UL9540A Test Standard for IQ Battery 10T

Overview

1. Order Details

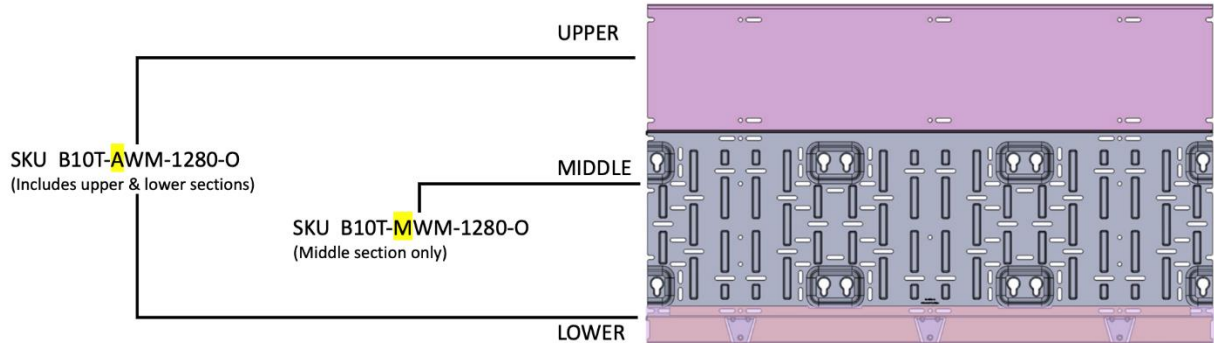
Please note that both Item 1 and 2 must be ordered for the 10T to reach the UL9540A test standard. The image below shows how the new parts fit into a 3-piece assembly.

- When wall mounting an IQ Battery 10T tested for UL9540A, three items are needed
- They ship in two boxes, under two-part numbers

Order the "IQ Battery 10T– Tested Parts" listed below through your distributor.

2. Quick Install Guides

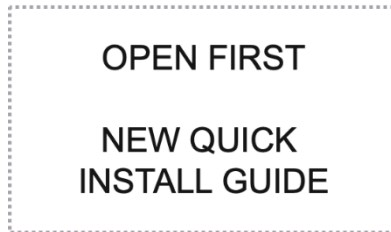
- **KEEP** - Once you have received the shipment, please follow the [NEW Quick Install Guide](#) attached inside the box labeled "OPEN FIRST – NEW QUICK INSTALL GUIDE."

The box contains the Additional Wall Mounts (AWM's) and will have this sticker attached on the cover. The new quick install guide has a PN on the bottom left corner of the packet: 140-00176-07.

- **REMOVE** - There is an OLD Quick Install Guide located in the Base Unit Box labeled B03-T01-US00-1-3 that should be disposed of.
